APPLICATION NO.	FILING DATE	FIRST NAMED INVENTOR	ATTORNEY DOCKET NO.	CONFIRMATION NO.
10/707,805	01/13/2004	Yi-Nan Chen	NTCP0027USA	1804
27765	7590	03/20/2006	EXAMINER	
NORTH AMERICA INTELLECTUAL PROPERTY CORPORATION P.O. BOX 506 MERRIFIELD, VA 22116			GEBREMARIAM, SAMUEL A	
			ART UNIT	PAPER NUMBER
			2811	
DATE MAILED: 03/20/2006

Office Action Summary

DETAILED ACTION

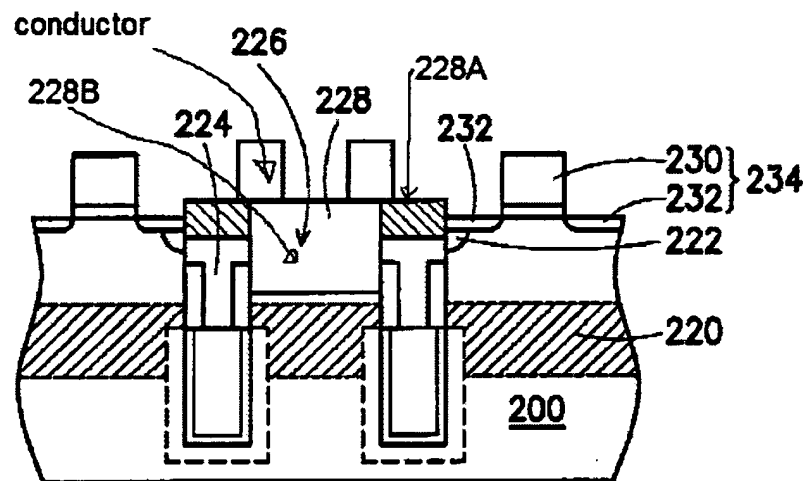
Regarding claim 1, Lee teaches (figs. 2A-2E and refer to the insert) an isolation structure (228) of a trench capacitor (col. 3, lines 39-42), the trench capacitor being disposed in a deep trench (210) of a substrate (200) and comprising: a storage node (214,224) serving as a top plate of the capacitor in the deep trench (210); a bottom plate buried (216) in the substrate around the deep trench (210); a capacitor dielectric layer (212) positioned between the storage node (214) and the bottom plate (216), on a sidewall of the deep trench, the storage node (214) the bottom plate (216) and the capacitor dielectric (212) forming storage capacitance; and a collar oxide layer (218) disposed on the sidewall of the deep trench (210), the isolation structure (228) comprising (fig. 2E): a first isolation portion (228A on both sides) directly contacting and completely covering the top surface of the storage node (214,224) to separate and isolate the storage node from other conductive elements (conductor element above 224) positioned above the storage node (refer to the figure below), the first isolation portion (228A on both sides, refer to the insert) completely filling a top opening of the

deep trench (210) and, having a first thickness (the depth of 228A); and a second isolation portion (228B) directly contacting the first isolation portion (refer to figure below) and surrounding the deep trench without overlapping the deep trench (refer to figure below), the second isolation portion having a second thickness larger than the first thickness (the depth of 228B is larger than 228A), the second isolation portion (228B) directly contacting and positioned beside and adjacent to both a top portion of the storage node (224) and a top portion of the collar oxide layer (218, refer to fig. 2E).
